Project: **LMCSD Indian Creek Elementary  
School ADA Improvements**

Re: COR #1

SITE LAYOUT, UTILITY AND  
ELEVATION PLAN

SHEET  
C2.0

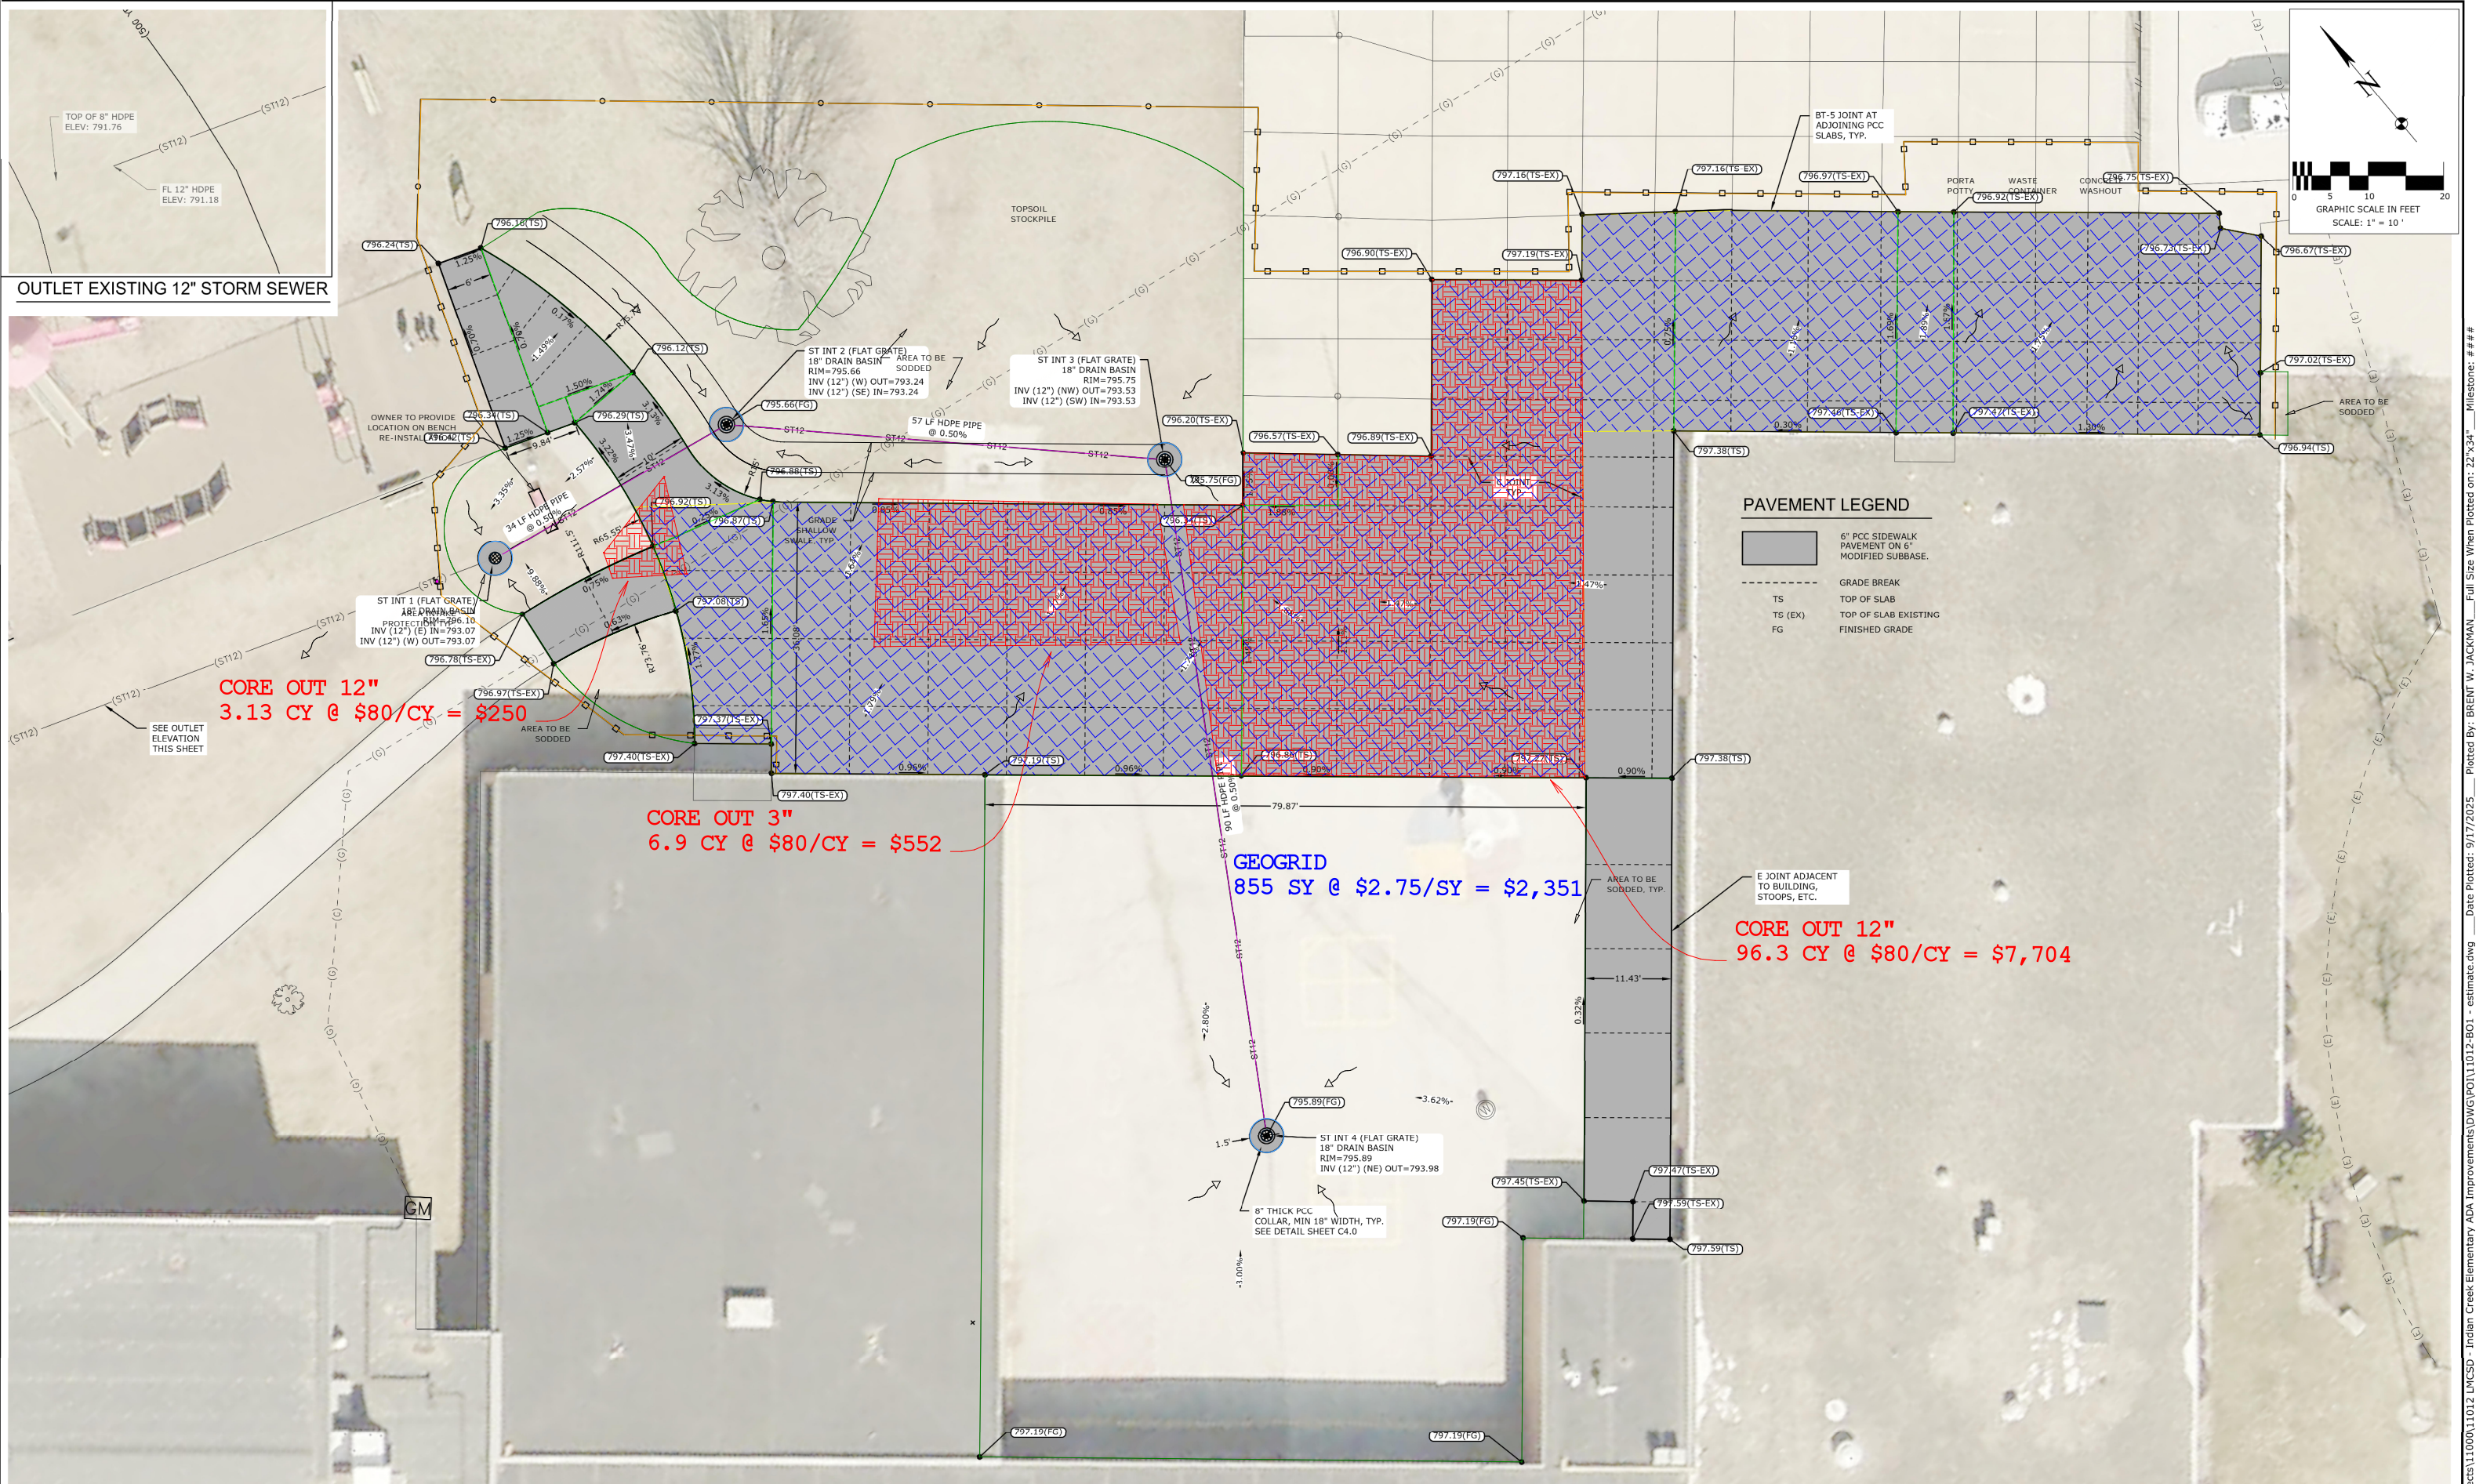
I am hereby submitting the following change order request to cover core out and geogrid in paved areas as recommended by Brent Jackman following a proof-roll on 11/20/2025.

Description	Qty	Unit	Unit Price	MU	Unit w/ MU	Total
12" Core out area (west)	3.13	CY	\$80.00	0.00%	\$80.00	\$250.40
3" Core out area	6.90	CY	\$80.00	0.00%	\$80.00	\$552.00
12" Core out area (east)	96.30	CY	\$80.00	0.00%	\$80.00	\$7,704.00
Geogrid beneath subbase	855.00	SY	\$2.75	0.00%	\$2.75	\$2,351.25
						<b>\$10,857.65</b>
